# UNITED STATES PATENT AND TRADEMARK OFFICE

10/018,303	10/30/2001	Osamu Sakai	10059-400US (P23013-01)	4864
------------	------------	-------------	----------------------------	------

<b>Office Action Summary</b>	<b>Application No.</b> 10/018,303	<b>Applicant(s)</b> SAKAI ET AL.	
	<b>Examiner</b> Raymond Alejandro	<b>Art Unit</b> 1745

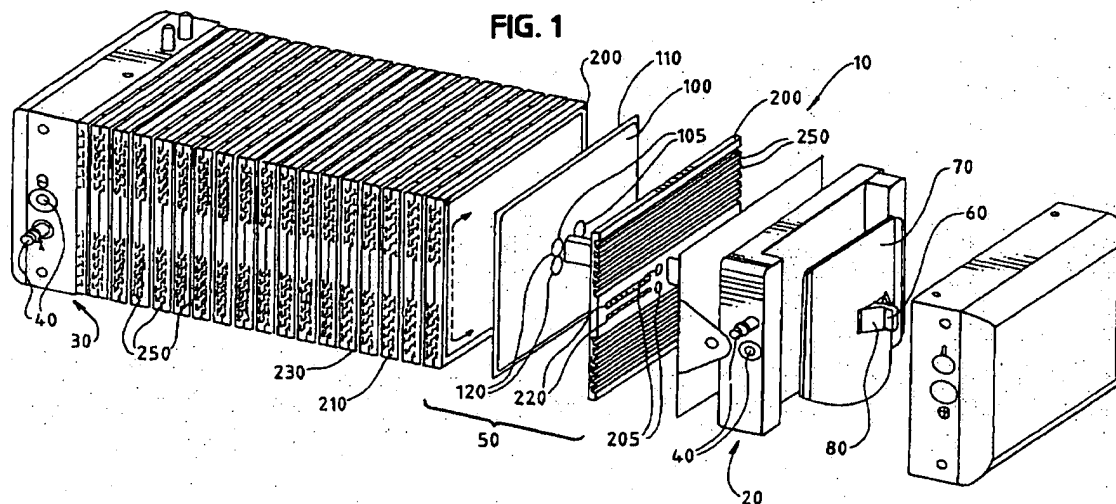
Barton et al disclose an electrochemical fuel cell stack with an improved compression assembly (TITLE). Figure 1 illustrates a solid polymer electrochemical fuel cell stack 10 including a pair of end plate assemblies 20 and 30, and a plurality of stacked fuel cell assemblies

50, each comprising an MEA 100, and a pair of flow field plates 200 (*the flow field plates are also known in the art as separators*) (COL 7, lines 64-67). As illustrated in Figure 1, each MEA 100 is positioned between the active surfaces of two flow field plates 200. Each flow field plate 200 has flow field channels 210 on the active surface thereof (which contacts the MEA) for distributing fuel or oxidant fluid streams to the active area of the MEA 100 (COL 8, lines 23-33). In the illustrated embodiment, flow field plates 200 have a plurality of open-faced parallel channels 250 formed in the non-active surface thereof (COL 8, lines 34-39).

It is disclosed that an elongate tension member extends between and through the end plate assemblies 20 and 30 to retain and secure stack 10 in its assembled state. It is further disclosed that spring plate 70 along with end plates 20 apply a compressive force to fuel cell assemblies 50 of stack 10 and act as restraining members (COL 8, lines 1-7). *It is apparent from Figure 1 above that the end plate assemblies 20, 30 form a gap therebetween so as to accommodate the fuel cell units in a sandwiched arrangement (that is, the end plate assemblies are spaced apart so as to dispose between the two of them the fuel cell units).*

*It is also apparent from Figure 1 above that a laminated and compressed configuration is formed when all components of the solid polymer fuel cell stack with a compression assembly comprising the tension member and a spring plate acting as a unitary resilient restraining member are put together. That is, they all become united into a single unit by compression means and/or a single unit is made by uniting or holding together superposed layers of the MEA, the separator (fluid flow field plate) and the end plates.*
